Council Report

Date: April 3, 2023
To: Donny van Dyk, Chief Administrative Officer
From: Nicole Capewell, Planner II
Address: 674 and 686 Martin Street

Subject: Official Community Plan Amendment Bylaw No. 2023-10
Zoning Amendment Bylaw No. 2023-11
Development Permit PL2022-9448
Road Closure and Land Disposition

Figure 3 - Road Dedication Plan showing subject piece of road

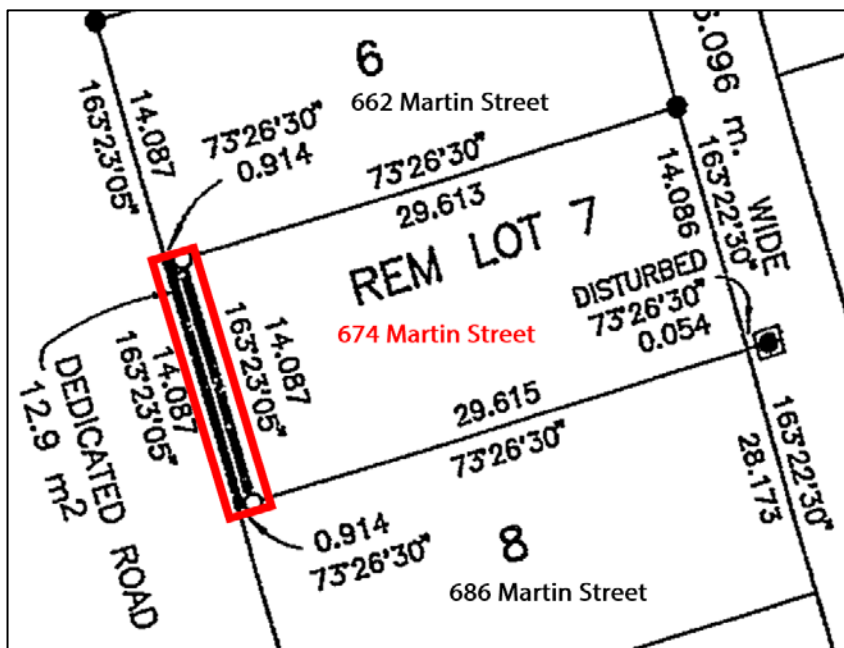
In addition to standard technical comments, the applicant is proposing to purchase back a piece of road right-of-way that was previously taken by the City (Figure 4). The (0.914 m wide) section of road right-of-way that is proposed to be sold back to the owner was originally desired by the City to allow for the future widening of Martin St, to meet the requirements within the Subdivision and Development Bylaw. The proposed property line is in alignment with adjacent property. The applicant will be required for future infrastructure requirements to be approved by the property owner.

proposed property line is in alignment with adjacent properties. Staff do not believe this land is expected to be required for future infrastructure requirements, and therefore support the request to transfer the lands to the property owner.
